ENGINEERING CHANGE NOTICE

Proj. ECN W-105-172

2. ECN Category (mark one)	3. Originator's Name, Organization, MSIN, and Telephone No.		4. Date
Supplemental ☒	K.L. EWER, KEH, E6-04, 6-1294		3-19-92
Direct Revision ☐	5. Project Title/No./Work Order No. W-105/ 242-A EVAP RETTN BASINS	6. Bldg./Sys./Fac. No. 242-AL	7. Impact Level / SC 3EQ / 3
Change ECN ☐			
Temporary ☐			
Supersedure ☐	8. Document Number Affected (include rev. and sheet no.) SEE BLOCK 12	9. Related ECN No(s). SEE BLOCK 12	10. Related PO No. N/A
Discovery ☐			
Cancel/Void ☐

13a. Justification (mark one)	13b. Justification Details
Criteria Change ☒	ITEMS 9, 12-17; LOI 93 - DIRECTS KEH TO PROVIDE LEAK DETECTION INSTRUMENTATION AT CATCH BASINS WITH LOCAL ANNUNCIATION & ALARM AT 242-A EVAP.
Design Improvement ☐	
Environmental ☐	
As-Found ☐	ITEMS 1-8, 10-19; LOI 95 - PROVIDE CONTINUOUS LIQUID LEVEL INSTRUMENTATION FOR BASINS (6" NORTH SAMPLE PORT RISER) AND LEACHATE SUMPS (4" LEACHATE RISER) WITH LOCAL READ-OUT & 242-A ALARMS
Facilitate Const. ☐	
Const. Error/Omission ☐	
Design Error/Omission ☐

242-A EVAPORATOR BUILDING WIRING DIAGRAM

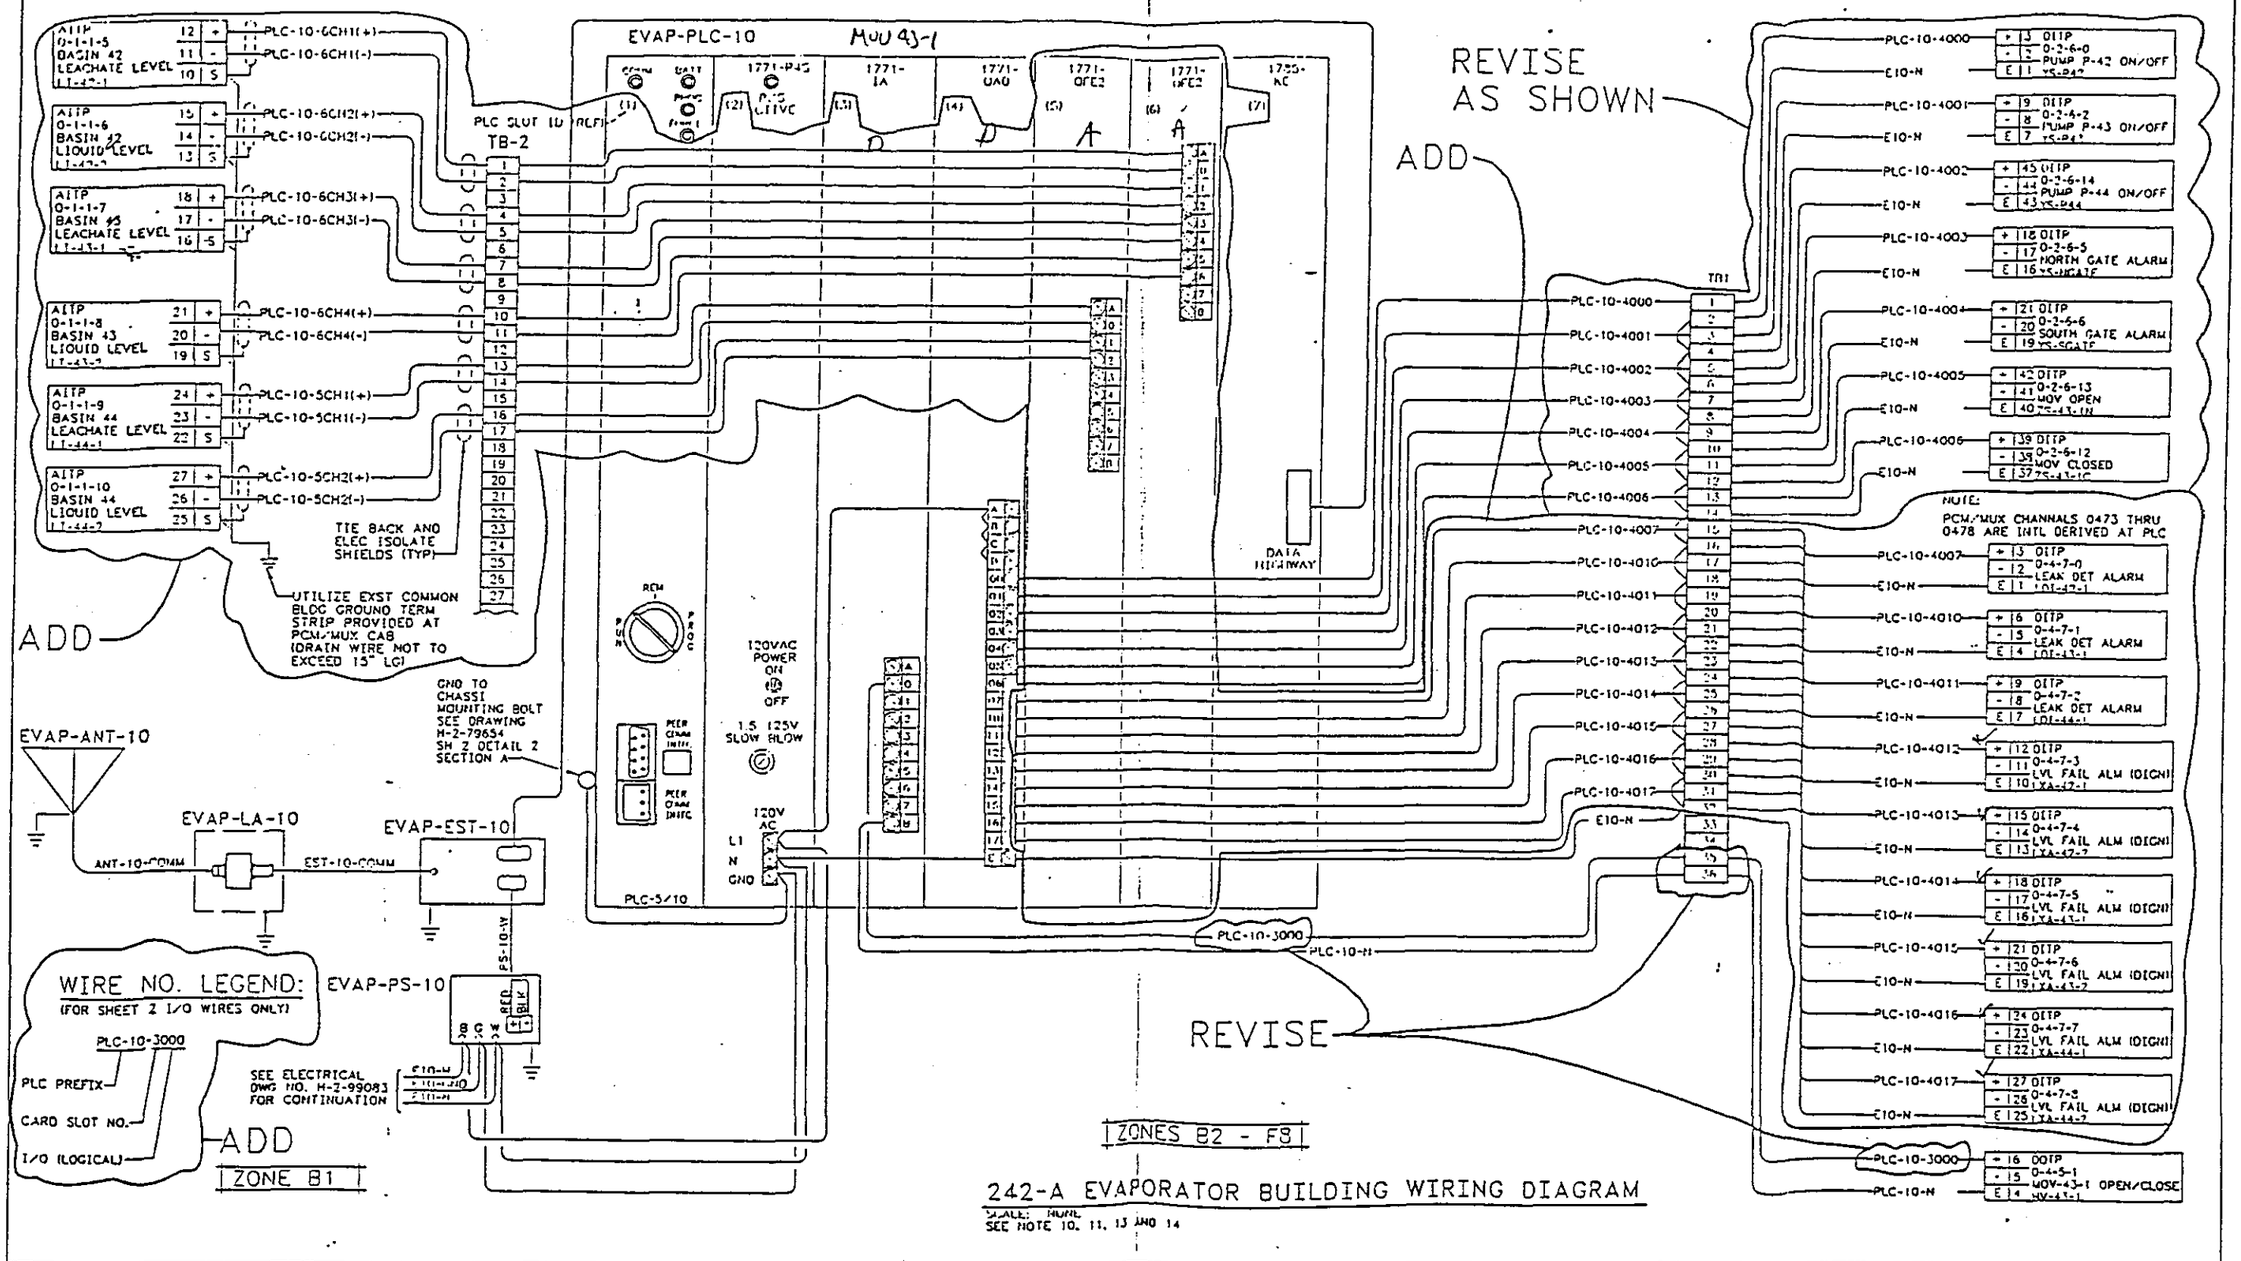
17. REVISE WIRING DIAGRAM PER PAGE 21.
